# Access Compliance Report

## Public Rights-of-Way

### (Curb Ramps)

Intersection ID: 10033028	Main Street: NOBLES_AV	Cross Street: N/A	Location: NW
ADA ID: 90609CA8BDCD	Ramp Type: Perp	Initial Pass/Fail: Fail	Overall Compliance: No
Severity Score: 13.75			
Codes/Mitigation Info/Possible Solution		Field Measurements/Component Compliance

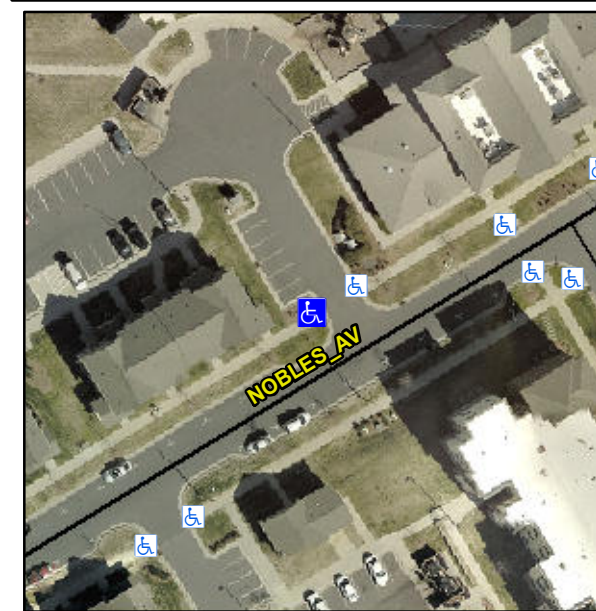
**R304.2.2, R304.5.3**

Compliance	Description	Data	Compliance	Description	Data
N/A	Ramp Length (in)	71.0	No	Ramp Slope (%)	8.9
Yes	Ramp Width (in)	70.0	No	Ramp XSlope (%)	4.0
N/A	Flare Type LT	N/A	N/A	Flare Type RT	N/A
N/A	Flare Slope LT (%)	N/A	N/A	Flare Slope RT (%)	N/A
N/A	Flare Traversable LT?	N/A	N/A	Flare Traversable RT?	N/A
N/A	Landing Length (in)	N/A	N/A	DWS Provided?	N/A
N/A	Landing Width (in)	N/A	N/A	DWS Contrast?	N/A
N/A	Landing Slope (%)	N/A	N/A	DWS Length (in)	N/A
N/A	Landing X Slope (%)	N/A	N/A	DWS Full Width?	N/A
N/A	Landing Curb? (Y/N)	N/A	N/A	DWS Offset (in)	N/A
N/A	Shared Landing?	N/A			
N/A	Gutter Ponding?	N/A	N/A	Gutter Slope (%)	N/A
N/A	Gutter Lip Ht (in)	N/A	N/A	Gutter X Slope (%)	N/A
N/A	Painted X Walk1?	No	N/A	Painted X Walk2?	N/A
	X Walk 1 Direction	To E		X Walk 2 Direction	N/A
N/A	X Walk 1 Width (in)	N/A	N/A	X Walk 2 Width (in)	N/A
	X Walk 1 Slope (%)	6.1		X Walk 2 Slope (%)	N/A
	X Walk 1 X Slope (%)	0.9		X Walk 2 X Slope (%)	N/A

**Remove & Replace Entire Ramp.**
